PUBLIC HEARING: July 19, 2018 – Planning and Land Development Regulation

CASE NO: V-18-062

SUBJECT: Variance to the maximum wall height requirements on Urban

LOCATION: 6270 S. Atlantic Avenue, New Smyrna Beach

Rear Wall (Phase 1 Complete)

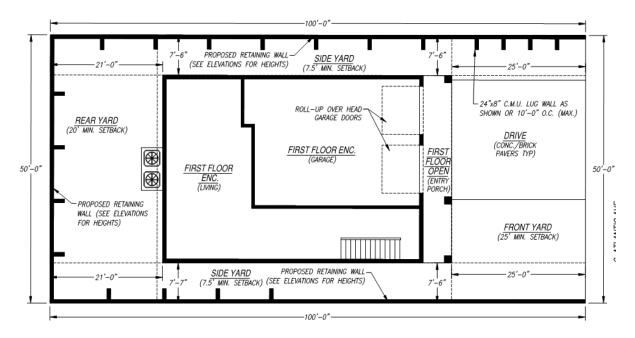
To prevent the continued run-off of fill material, the contractor received approval for an additional building permit in May 2018 to construct a six-foot tall, concrete retaining wall along the perimeter of the rear and side yards, and a four-foot tall, concrete retaining wall along the north and south side lot lines in the front yard area. Pursuant to Section 72-282 of the Zoning Code:

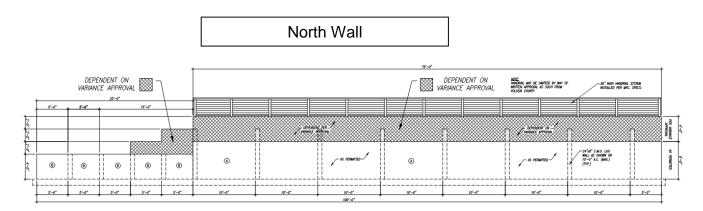
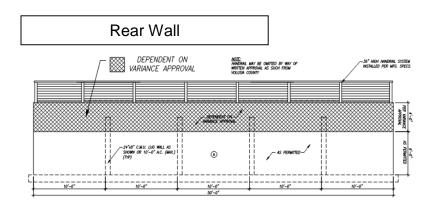
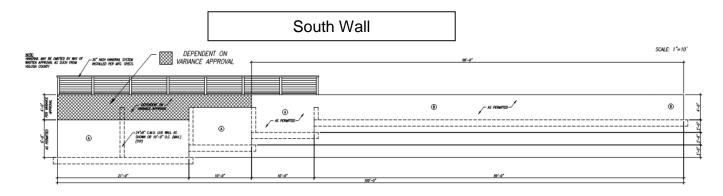
The applicant is seeking variances for "Phase 2" of the wall to increase the height in the rear and side yards incrementally from six to 10 feet tall (see attached variance site plan). A safety railing may also be required by the building official due to the extreme drop off between parcels. A three-foot tall safety railing meets the minimum safety requirements for residential structures. A variance from the PLDRC will not be needed for the safety railing as long as the railing or fence has an opacity of 25 percent or less and is erected to meet the minimum safety requirements of the Florida Building Code.

The north side yard retaining wall is proposed to extend into the front yard, so the applicant is also requesting a variance in portions of the north front yard to increase the retaining wall height incrementally from four feet to 10 feet tall.
